**Report of**  
**The Brookline Neighborhood Conservation**  
**District Commission**  
**on**  
**Site Eligibility of the Hancock Village c.40B Proposal**

(Proposal Dated June 10, 2013)

Submitted August 9, 2013

FIGURE 8

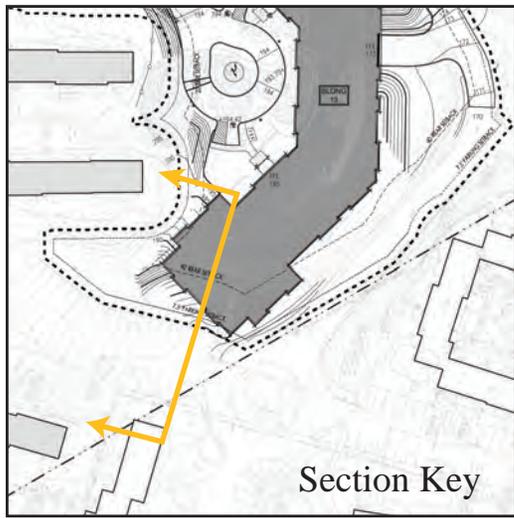
Third, the proposal violates Hancock Village’s defining circulation concept, the separation of pedestrian ways from vehicular circulation. The layout within the northern greenbelt is particularly inappropriate in this respect. It situates paved parking areas and structured garages between the proposed flats whose only pedestrian access is the new roadways serving them. The resulting dead-end roadways are inconsistent with the NCD guidelines intended to preserve the existing curvilinear circulation patterns. It should be noted that the configuration of the proposed roadways also raises serious concerns about traffic safety.

FIGURE 9 Site Section --Differentials in Height, Topography, Proximity  
Source: Town of Brookline Planning Department

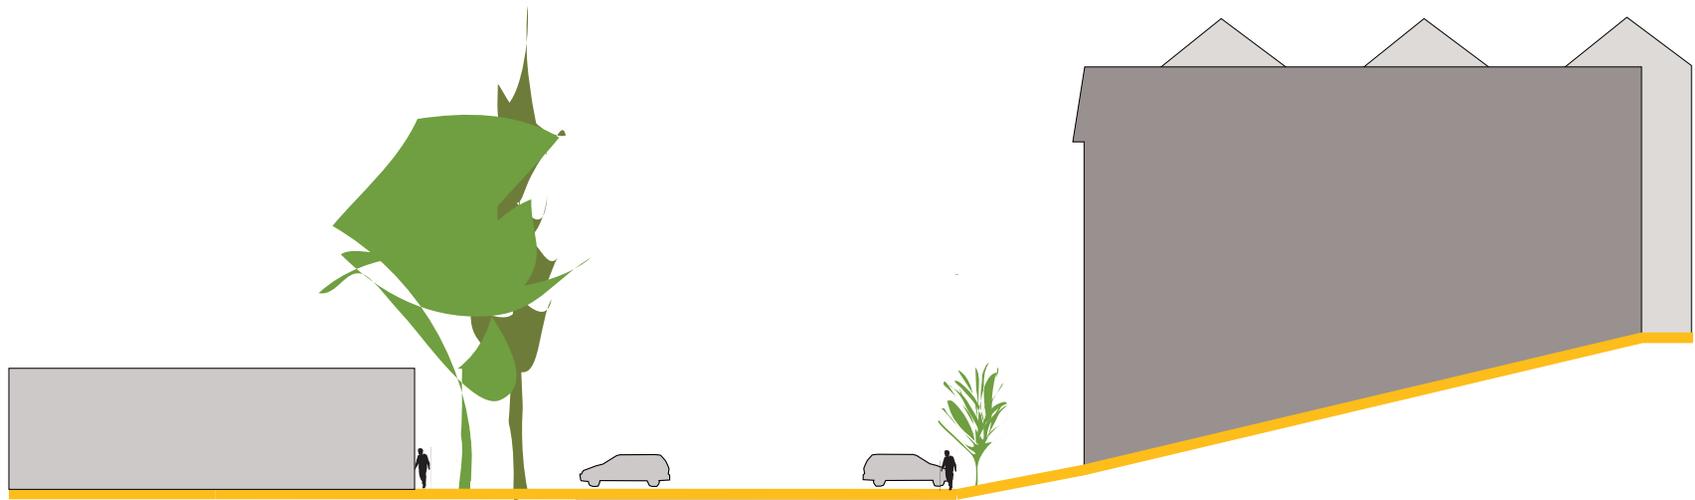
Whereas the proposed townhouses are inappropriate to their site, the apartment building is entirely out of scale with its context. A symmetrical, largely monolithic structure 51 to 74 feet in height, depending on grade and the elevation, it would be located at the village’s highest point and would therefore loom over the adjacent townhouses. It would put the townhouses to its immediate west in shadow and blot out their sky-shed. The north and south elevations of the apartment building present the most bulk, ranging from 400 to 530 feet long. The Commission noted that the site section submitted by the developer was chosen to minimize the differentials in height, topography, and distance between proposed and existing structures. **Figures 9 and 10**, prepared by the Town Planning Department, illustrate the overbearing visual relationship between the south elevation and the townhouse clusters to its south and west. The conflict between its massing and architectural style and that of the village’s townhouses is not ameliorated by the busy hipped roofs and faux mansards that replaced the flat roofs presented in the 2012 proposal. These architectural treatments do nothing to mitigate the building’s symmetrical box-like structure and horizontal bulk.

FIGURE 11

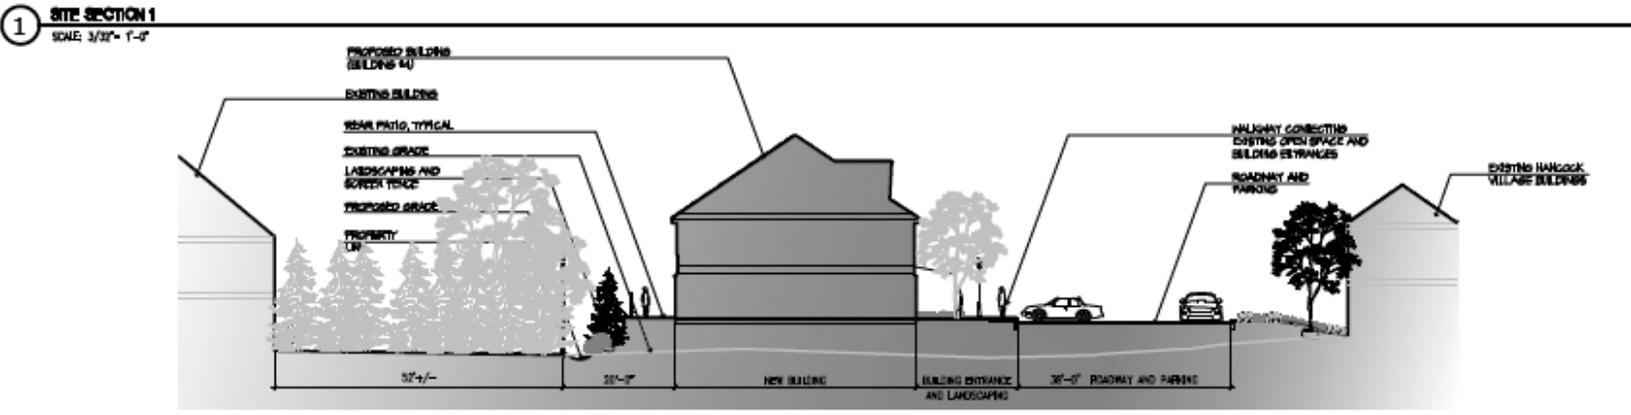
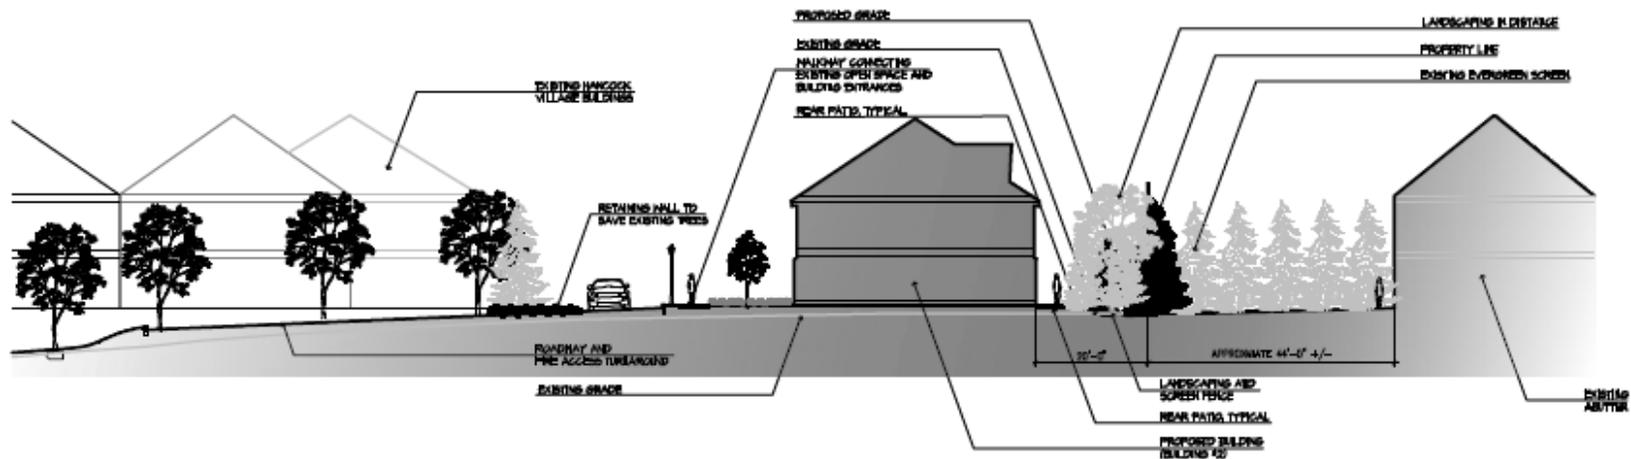
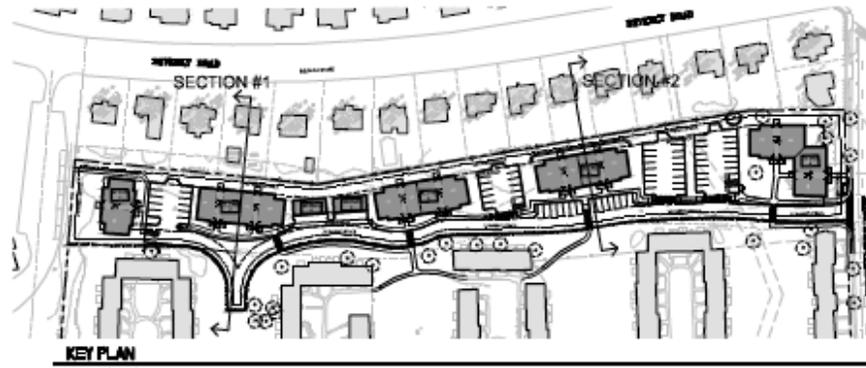
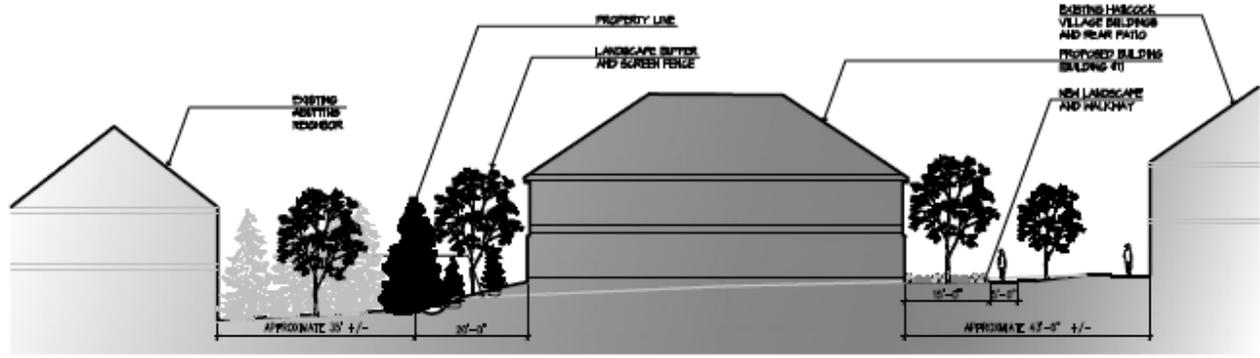
The flats proposed within the greenbelt are also out of character with Hancock Village’s existing townhouses. They are wider in dimension, they do not have similar rear yard depths, and some are placed at odd angles, making their lack of conformity more glaring.

FIGURE 14 Site Plan Sheet A: Grading Contours, West Parcel

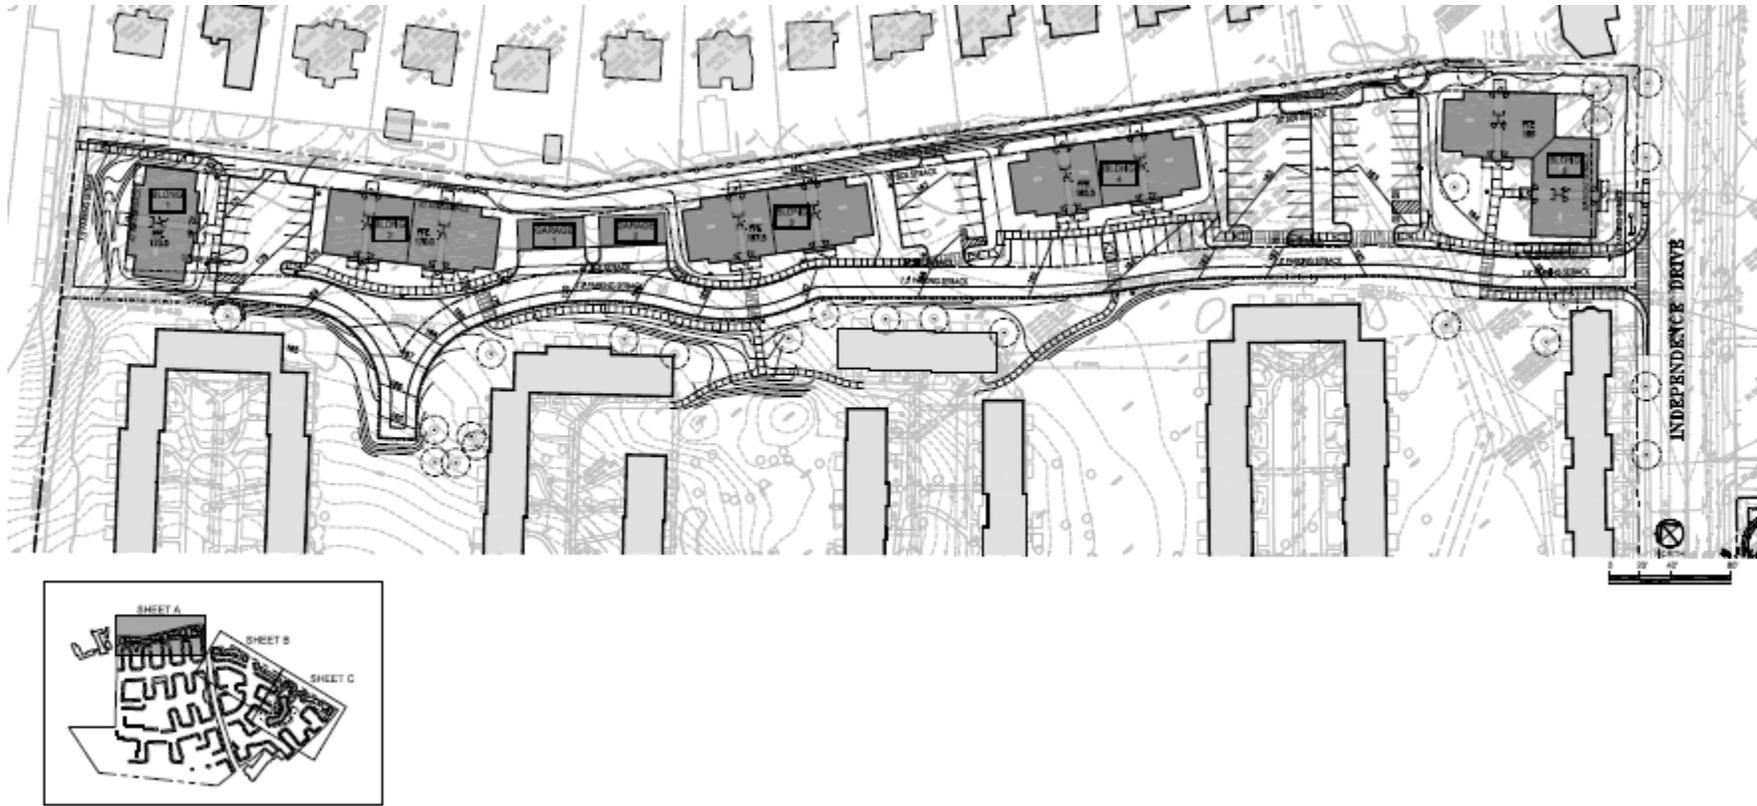
As noted above, Olmsted Associates' Hancock Village townhouses, paths and open spaces utilize the site's distinctive topography and characteristic rock outcroppings to give the village its defining character, that of residences set densely but appropriately within a green natural environment of great visual interest. The project would destroy that character at the sites it proposes to redevelop, first by leveling the rock outcropping and replacing the urban wild within the north-south open space corridor with an apartment block and second, by replacing its undulating linear park with a development zone that would flatten its contours and destroy its mature trees to accommodate parking. The Commission also notes that most of the proposed housing closest to Beverly Road is inappropriately sited four feet above the adjoining topography (to the north and south).

In addition to the visual impacts of these measures, the Commission is concerned with the impact of such extensive tree removal and of the parking areas' impervious surfaces on site drainage, particularly on the lower elevation homes on Beverly and Russett Roads.

FIGURE 16 Site Plan Sheet C: Grading Contours, East Parcel, Apartment Building Source: Chestnut Hill Realty c.40B Proposal, June 10, 2013

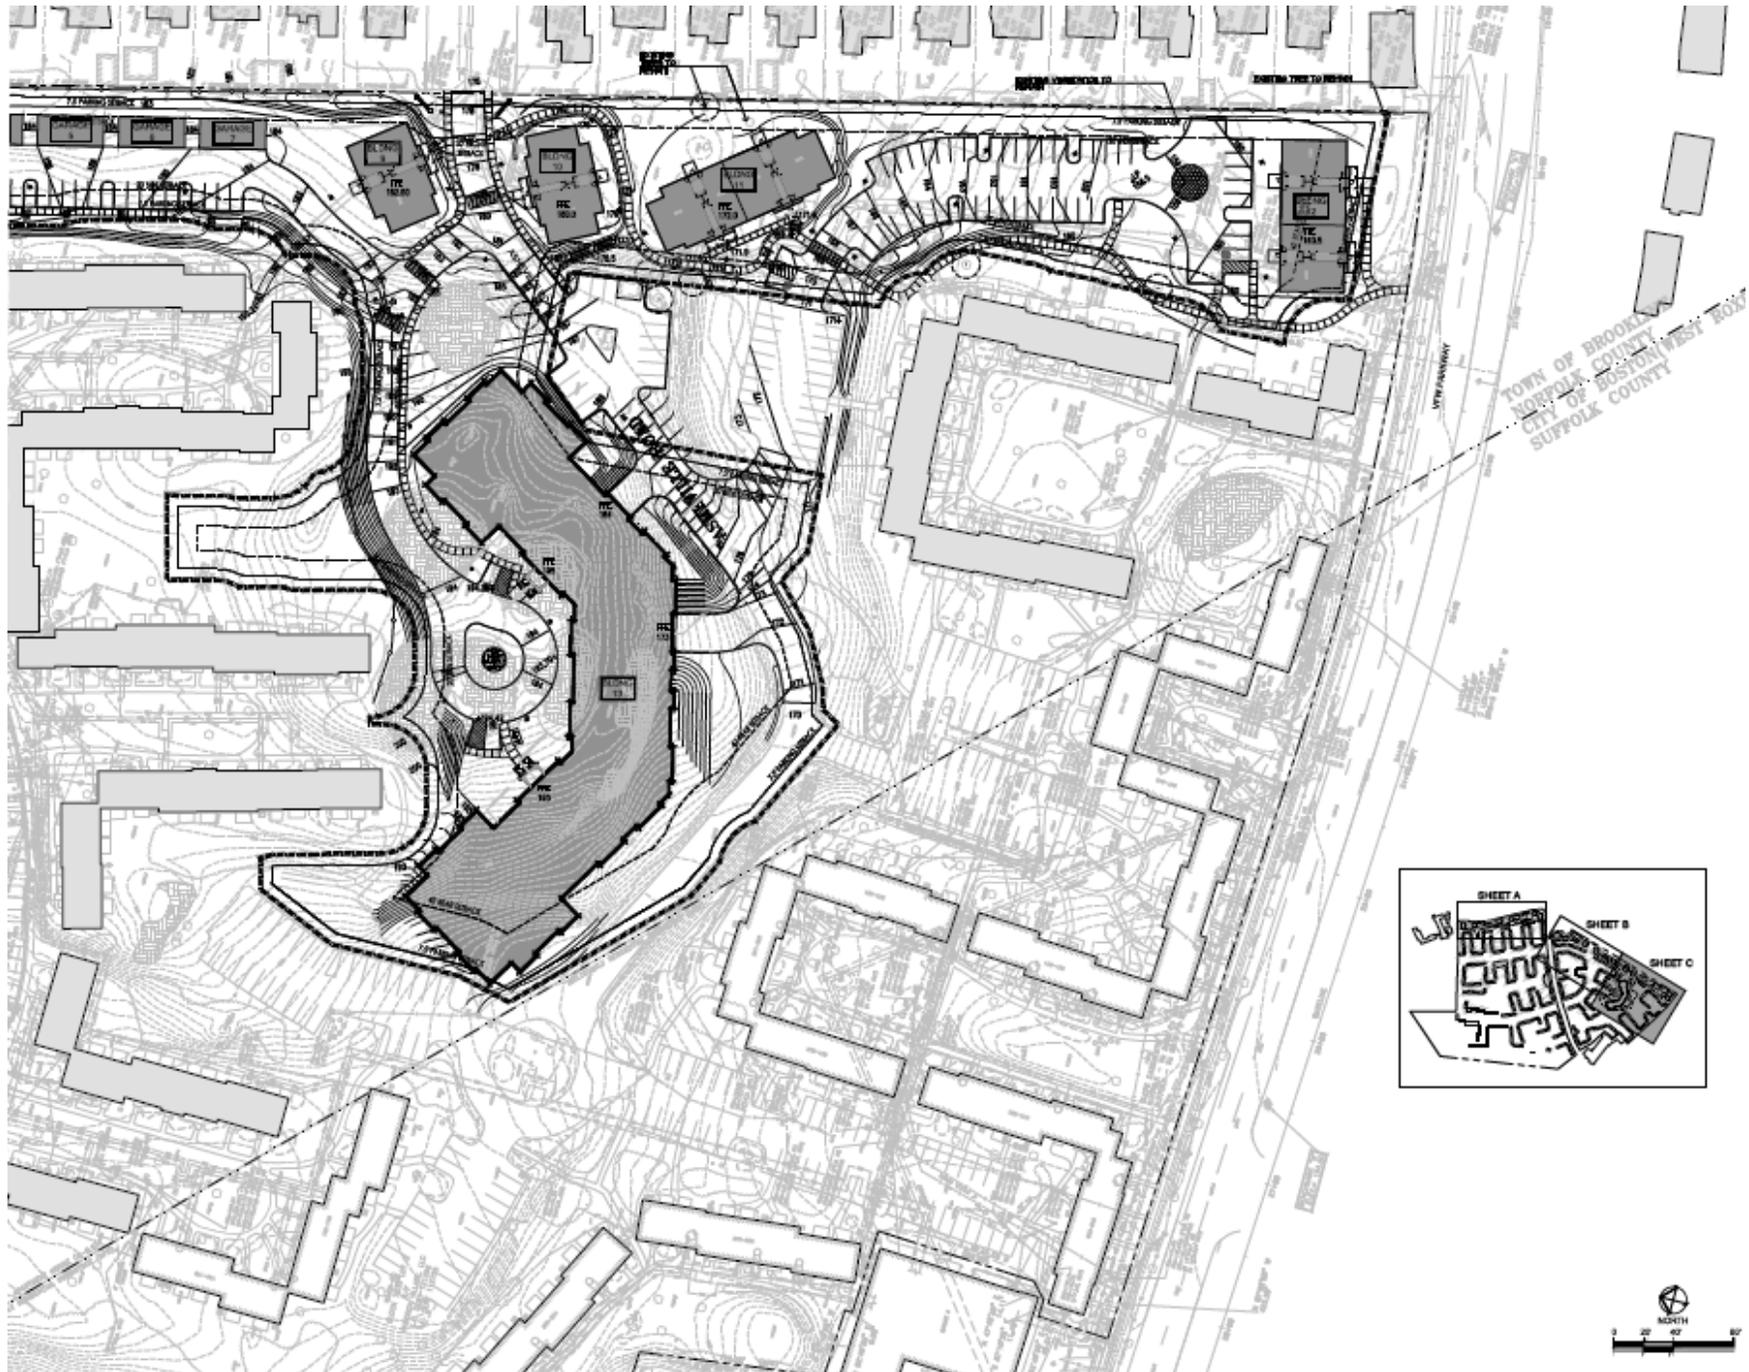
In addition to eliminating the greenbelt, the proposal destroys the open space corridor running north-south through the site and its crowning feature, its elevated puddingstone outcropping. It would obliterate the ledge and eliminate it as an open space by siting a four-story apartment building atop it. These elements
